**Staff Report to the
Municipal Planning Board
August 21, 2018**

**CUP2018-10012
Item #2
TRC DRAFT**

WEST LAKE EARLY LEARNING CENTER (ELC)

Site Plan

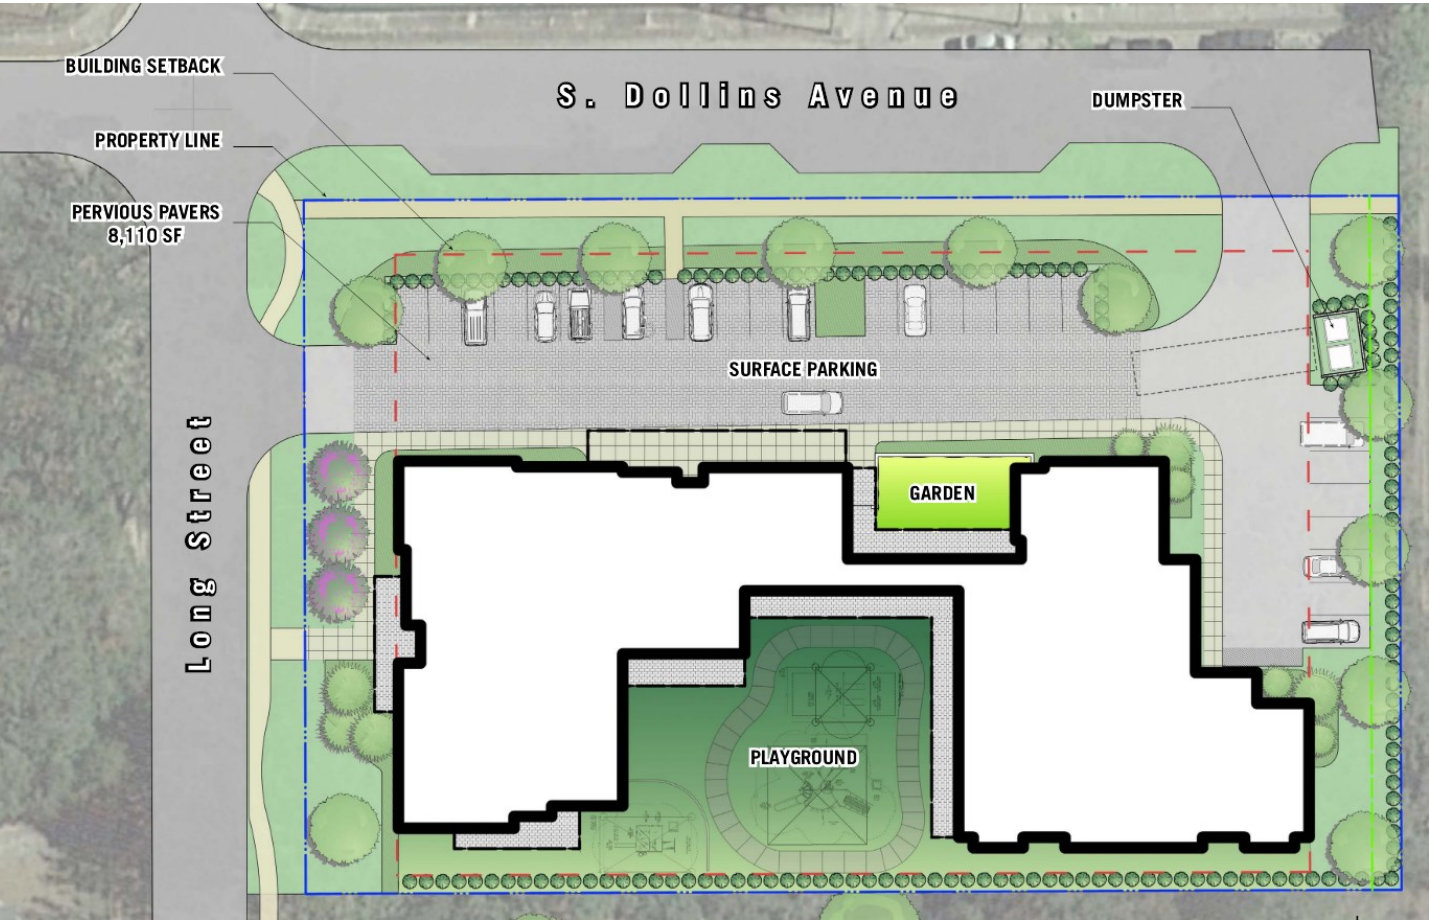
8. **Height.** The building height must not exceed 35 ft.
9. **ISR.** The ISR must not exceed 0.55.
10. **Garden.** The garden shown on the site plan is to be an ancillary, educational use with no produce to be sold on-site.

7. Street trees must be provided along S Dollins Ave. Street trees are required within established rights-of-way along public and private streets. Trees can occur within the right of way or within the bulbouts.

2. The sidewalk along Dollins Av should be installed within the right-of-way abutting the back of curb for the new parking stalls. The minimum width is 6 ft.

3. The sidewalk ramps at the intersection must be brought into ADA compliance. Unless unreasonably constrained, individual ramps for the east and north directions must be used. The owner is also responsible for installing the crosswalks on the south and west approaches according to MUTCD and City standards.

4. The crosswalks from the parking stalls to the building entrance and at the 2 driveways must be installed per MUTCD and City standards.
5. Bicycle Parking is not required by Code for this use but should be installed for use by employees and patrons.

Elevations

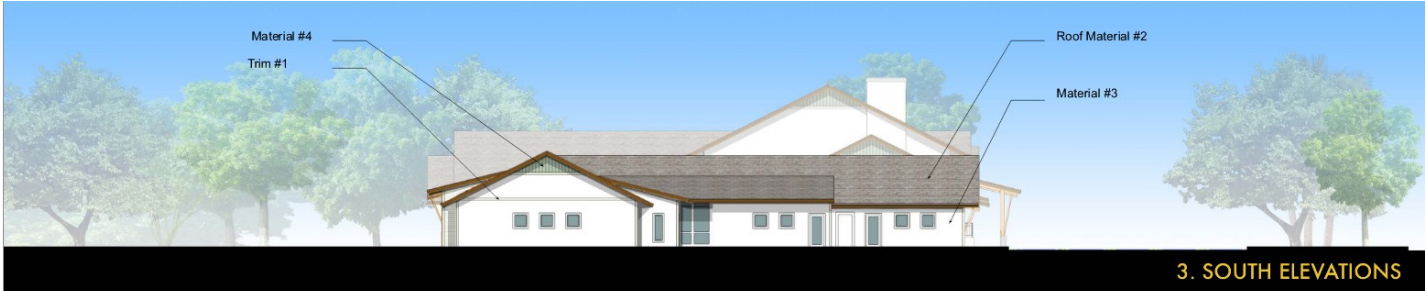
1. **Appearance Review** shall be required prior to submitting to Permitting to ensure permit elevations match elevations submitted within this application.
